intel® Technical Advisory

TA-0645-4

April 28, 2003

Intel® Server Boards SE7501BR2 and SE7501HG2 FRUSDR version 5.5.B does not support default shipping configuration of the Intel Server Chassis SC5200 Hot-Swap Redundant Power.

Figure 1. SC5200 HSRP Power Supply Module & AC Inlets

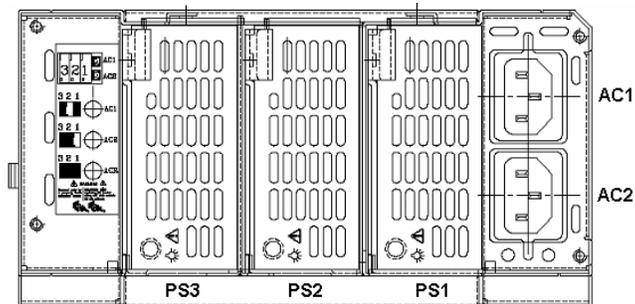
The Intel Server Chassis SC5200 (HSRP) Hot-Swap Redundant Power ships from factory with two 350W power supply modules installed in slots PS2 & PS3 (refer to figure below), a third power supply module can be purchased as an accessory to enable full power redundancy. The power supply cage enables two Alternating Current inlets to power all three modules: AC1 powers modules PS1 and PS3, and AC2 powers modules PS2 and PS3. With two power supply modules installed in PS2 and PS3, the system requires AC presence only on the AC2 inlet.

When updating the Intel Server Boards SE7501BR2 and SE7501HG2 with their FRUSDR utilities (version 5.5.B), the update utilities incorrectly request movement of these two power supply modules to positions PS1 and PS2. In this condition, only the PS2 power supply is powered when only AC2 is present; exposing the potential for exceeding power rails which could result on a system reboot. This issue is not exhibited in a fully power redundant configuration (i.e. 3 power modules and 2 AC cords present).

Intel is developing new BMC Firmware and new FRUSDR utility for the Intel Server boards SE7501BR2 and SE7501HG2 which will correct this situation, the following table details the version where fixed and estimated release date:

Intel recommends customers to update their Intel Server boards SE7501BR2 or SE7501HG2 installed in an Intel Server Chassis SC5200 HSRP to this new BMC Firmware and FRUSDR releases when available. The utilities can be downloaded from <http://support.intel.com> once available.
